FINAL | DECEMBER 2025
ENVIRONMENTAL IMPACT REPORT
SCH No. 2023100084

GINKGO STONEHOUSE RESIDENTIAL PROJECT

FINAL

ENVIRONMENTAL IMPACT REPORT

6-5

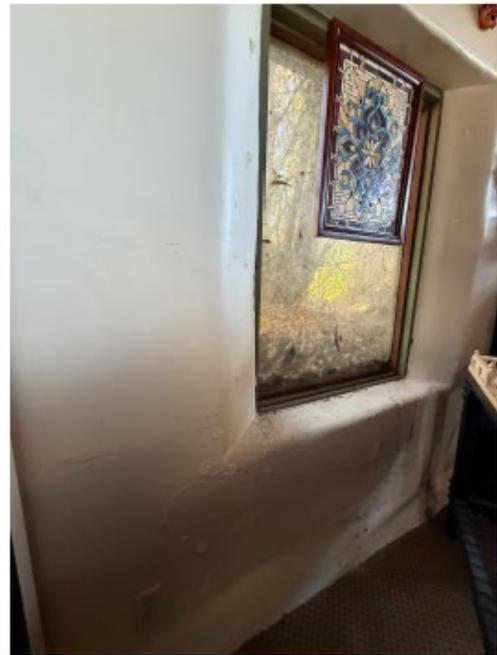
I have included photos of my carriage house with views from the street and also the north facing side, the carriage house interior with soil level outside the window and my carport/deck which is north of the carriage house.

SECTION A-A
SCALE: NTS

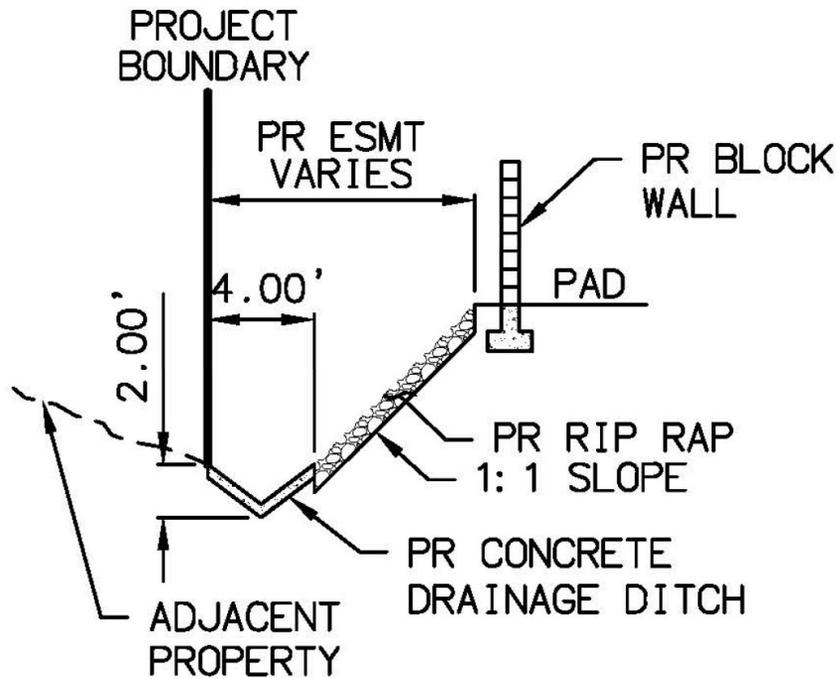
Comment 6-4: The commenter states concern regarding issues related to necessary clearances between their existing structures and any proposed structures on the Project site as well as concerns regarding issues related to grading between the properties and how existing buildings will be impacted by any grade changes. The commenter notes that the existing soil level to the east of the carriage house (shed) is 1-2 feet higher than it was in 2007 when the property was purchased. The commenter indicates that past heavy rains, vegetation decay and soil erosion on the Project site have likely caused the buildup of soils and vegetation decay on the Project site, which is now estimated at about 3-4 feet higher than their existing driveway and the floor of the carriage house.

Response: The Draft EIR included an abbreviated version of the Tentative Tract Map (TTM) in Figure 3-4 as the “detailed map”, which is required under CEQA Guidelines Section 15124, Project Description, part (a). The full TTM includes a cross-section “A-A”, which details how grading and drainage would be handled along the western edge of the Project site, which is the property line in question regarding the carriage house. As shown below, cross-section A-A shows the property line would be modified to include an adjacent 2-foot deep by 4-foot-wide concrete v-ditch followed by a riprap (rock) slope and concrete block wall. The proposed modified property line would remove the existing sediment and vegetation decay buildup and manage future stormwater flows and sediment transport in the long-term. Cross-section A-A is depicted as follows:
